POWDER SPRINGS PROPERTIES, LLC

Z-10
(2009)

PLANNING COMMENTS: **Staff Member Responsible:** John P. Pederson, AICP

Z-10 POWDER SPRINGS PROPERTIES, LLC

SITE LAYOUT

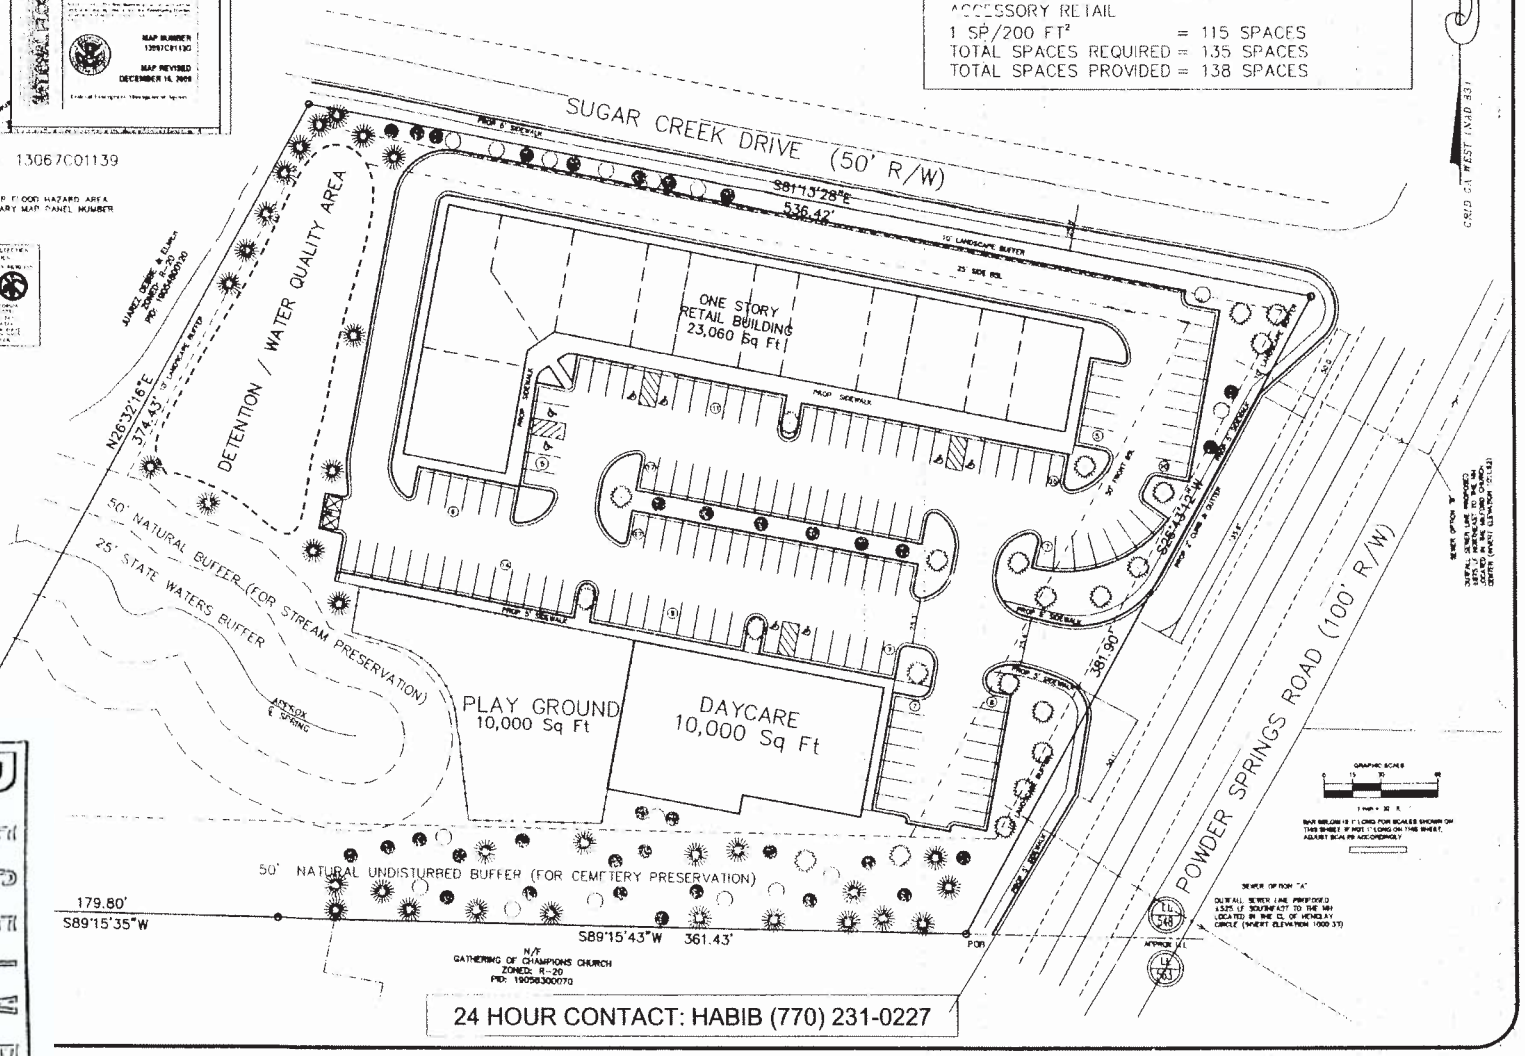
The applicant is requesting the NRC zoning district to develop a small shopping center and daycare facility on this property. The buildings will be one and two-stories in height with traditional building architecture; the exterior of the buildings would contain brick, stacked stone and/or EFIS. The applicant is showing contemporaneous variances to reduce the 20-foot landscape buffer adjacent to residential property to 10-feet. See Exhibit "A" for the applicant's Impact Analysis, and see Exhibit "B" for the applicant's letter of stipulations.

Cemetery Preservation: Petition shows the presence of Big Bethel Baptist Church cemetery adjacent to the southern boundary. The Cobb Cemetery Preserviation Ordinance and the County Development Standards for Cemeteries call for: A) Prepare a site plan that identifies the common boundary , and a metes and bounds description. B) Provide a fifty (50) foot undisturbed natural buffer from the common property line; or a fifty (50) foot undisturbed natural buffer around the perimeter of the outermost burials of the cemetery; whichever provides the greatest protection for the cemetery. The outermost burials to be determined by a professional archaeologist (Cobb County Code 26-29 Section C). The archeology survey will locate all grave shafts and define the boundary. Member(s) of Cemetery Preservation Commission must be present during archaeology survey. Lots adjacent to the fifty (50) foot undisturbed natural buffer shall have setbacks in addition to the buffer. The fifty (50) foot undistrubed natural buffer shall be recorded as a conservation easement with the Cemetery Preservation Commission having third party right of enforcement. C) A plat to be prepared by a registered surveyor denoting the location of all grave shafts, the cemetery property line and fence. The archaeology survey and the register surveyor's plat **must** be submitted to the Cemetery Preservation Commission three (3) business days prior to any zoning hearing, or three (3) business days prior to Plan Review if the subject tract is not being rezoned. D) Provide and install a permanent six (6) foot chain link fence outside the line of the outermost burials. Fence must be 9 gauge with top and bottom rails and fence posts must be set in concrete. Fence may be upgraded to vinyl coated chain link and/or wrought iron. E) Provide and install an orange protective fence on the outer perimeter of the fifty (50) foot undisturbed naturla buffer before beginnng construction. The protective fence to be maintained in good repair throughout the development phase of the project. At completion of the project, the orange protective fence shall be removed from the premises. F) Permanent signs stating **CEMETERY PRESERVATION BUFFER - DO NOT DISTURB** shall be erected at fifty (50) foot intervals along the outer perimeter of the fifty (50) foot undisturbed natural cemetery preservation buffer. G) Compliance with all State and local laws and ordinances. H) All Cemetery Preservation requirements must be Site Plan specific.

1. The existing site drains to the west via an existing ravine located near the southwest corner of the site. Development for commercial use will require significant site grading. The topography falls more than 30 feet across the site. With the exception of the small stream buffer area the site will be mass graded. Extra care must be exercised with the erosion control for this site to protect the downstream private lake located approximately 1500 ft downstream. As indicated in the Downstream Condition Comments, a pre- and post-development lake sediment study must be performed.

2. The existing tree stand and undergrowth provide significant air/water quality, soil stabilization and storm flow mitigation benefits for this watershed. Construction of this project will eliminate the vast majority of this vegetation as well as significantly increase pavement, storm runoff and non-point source pollution. To compensate, the First Flush Water Quality Best Management Practice Requirements must be elevated to the 1.5-inch rainfall event and each larger storm discharge controlled not to exceed the allowable discharge of the next lower, more frequent storm event (ie. 5-year storm event released at 2-year rate; 10-year event at 5-year rate; etc. to 100-year event at 50-year rate).

Install sidewalk, curb and gutter along road frontages.

No access to Sugar Creek Road.

A. It is Staff's opinion that the applicant's rezoning proposal will not permit a use that is suitable in view of the use and development of adjacent and nearby properties. The applicant's property has single-family detached uses on three sides, with a church and cemetery on the fourth side. Sugar Creek Drive is a small rural road with large acreage residential tracts.

B. It is Staff's opinion that the applicant's rezoning proposal will have an adverse affect on the usability of adjacent or nearby property. The applicant's proposal could encourage other rezoning applications that are not consistent with area. There is not a transition in zoning intensity, and the applicant is showing reduced buffers on the west and south property lines.

Recommend installing sidewalk, curb and gutter along the road frontages.

Recommend no access to Sugar Creek Road.

Recommend applicant be required to meet all Cobb County Development Standards and Ordinances related to project improvements.

Based on the above analysis, Staff recommends DENIAL.
